Access Compliance Report

Public Rights-of-Way

(Curb Ramps)

Intersection ID: 12983	Main Street: E_TRADE_ST	Cross Street: N_MYERS_ST	Location: N
ADA ID: ECA7EFE3751F	Ramp Type: Perp	Initial Pass/Fail: Pass	Overall Compliance: No
			Severity Score: 0.25

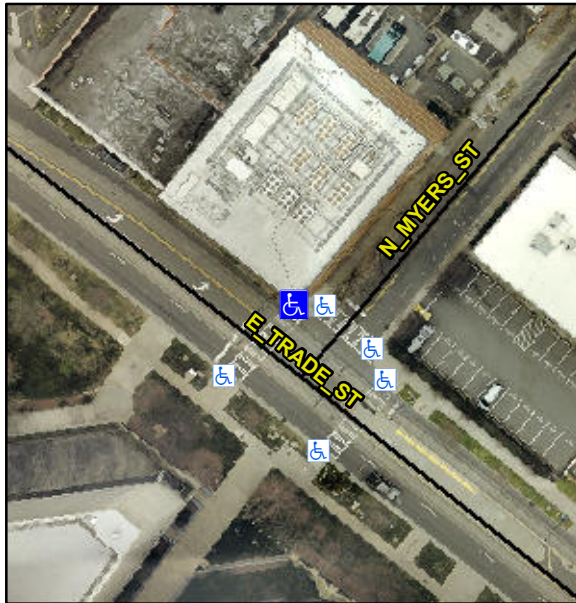
Not Found, R304.5.3, R305.2

Compliance	Description	Data	Compliance	Description	Data
N/A	Ramp Length (in)	70.0	Yes	Ramp Slope (%)	5.9
Yes	Ramp Width (in)	48.0	No	Ramp XSlope (%)	4.0
N/A	Flare Type LT	Sloped	N/A	Flare Type RT	N/A
N/A	Flare Slope LT (%)	10.5	Yes	Flare Slope RT (%)	6.2
N/A	Flare Traversable LT?	No	N/A	Flare Traversable RT?	Yes
Yes	Landing Length (in)	73.0	Yes	DWS Provided?	Yes
Yes	Landing Width (in)	52.0	Yes	DWS Contrast?	Yes
Yes	Landing Slope (%)	0.2	Yes	DWS Length (in)	24.0
No	Landing X Slope (%)	5.3	Yes	DWS Full Width?	Yes
N/A	Landing Curb? (Y/N)	No	No	DWS Offset (in)	2.5
N/A	Shared Landing?	No			
Yes	Gutter Ponding?	No	Yes	Gutter Slope (%)	3.2
Yes	Gutter Lip Ht (in)	0.0	No	Gutter X Slope (%)	2.8
N/A	Painted X Walk1?	Yes	N/A	Painted X Walk2?	N/A
	X Walk 1 Direction	To SW		X Walk 2 Direction	N/A
N/A	X Walk 1 Width (in)	112.0	N/A	X Walk 2 Width (in)	N/A
	X Walk 1 Slope (%)	1.3		X Walk 2 Slope (%)	N/A
	X Walk 1 X Slope (%)	2.3		X Walk 2 X Slope (%)	N/A

**Remove & Replace Entire Ramp.
Remove & Replace Gutter.**
